Remarks

This amendment is in response to the Office Action dated September 25, 2002. Claims 1, 5, 8, 17, 20 and 22 have been amended and new claims 24-25 have been added. Claims 21 and 23 have been canceled without prejudice. Claims 1-20, 22 and 24-25 are currently pending. Reexamination and reconsideration are respectfully requested.

Fig. 4

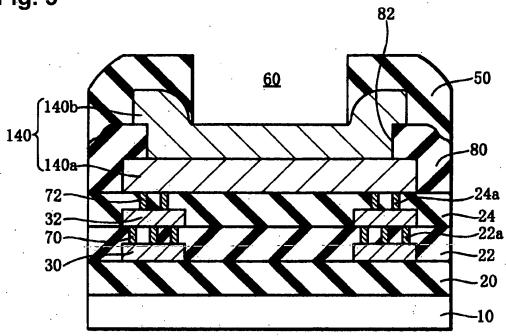
Applicant proposes to amend Fig. 4 as indicated in red on the attached sheet to include reflection prevention film 99. Support for the amendment may be found in the specification at, for example, page 10, line 28. Applicant will submit a new formal drawing if the proposed amendment is approved.

--(5) A reflection prevention film <u>99</u> may be formed on the third wiring layer 40. It is noted that, when a reflection prevention film <u>99</u> is formed, the reflection prevention film <u>99</u> at the pad opening section 60 may preferably be removed in order to improve the coherency between bonding structures (for example, bonding balls, bumps, etc.) and the third wiring layer 40. The reflection prevention film <u>99</u> may be formed from, for example, a titanium nitride film. The thickness of such a titanium nitride film is, for example, 20 – 80 nm.--
